P5008A-02

Information Only Service Note

P5008A Keysight Streamline USB Vector Network Analyzer

False alarm on self-test failure on firmware revision of A.13.40.02 - DDR3 memory removal

Self-test

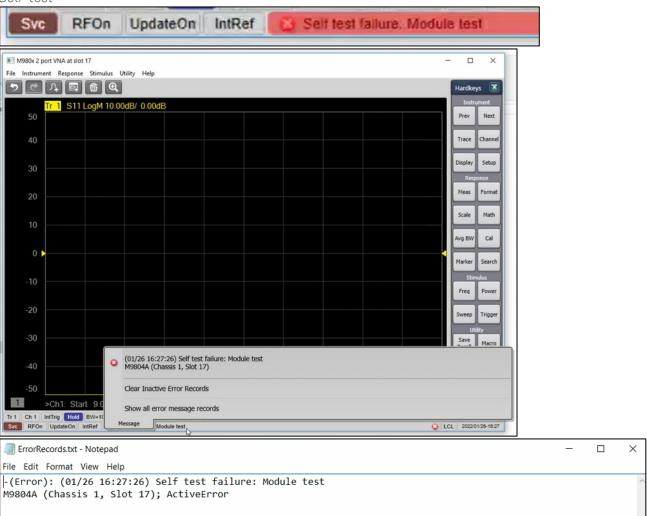
The on board DDR 3 memory in VNA is not in use since its release. With the removal of DDR 3 memory IC on newer P500xA VNA, right after firmware is launched, false alarm (self-test failure) will be reported as shown. This has no impact to VNA performance and specifications.

Similarly, firmware will report a false failure in Operator check. Shown are the error messages example on VNA firmware UI.

Since this DDR3 memory is not in use, newer firmware revision no longer consider it as the failure. Keysight recommends keeping VNA firmware up-to-date whenever it is possible.

For users with firmware revision of A.13.40.02, Update firmware to revision A.13.70.02 or newer to resolve this false alarm on self-test.
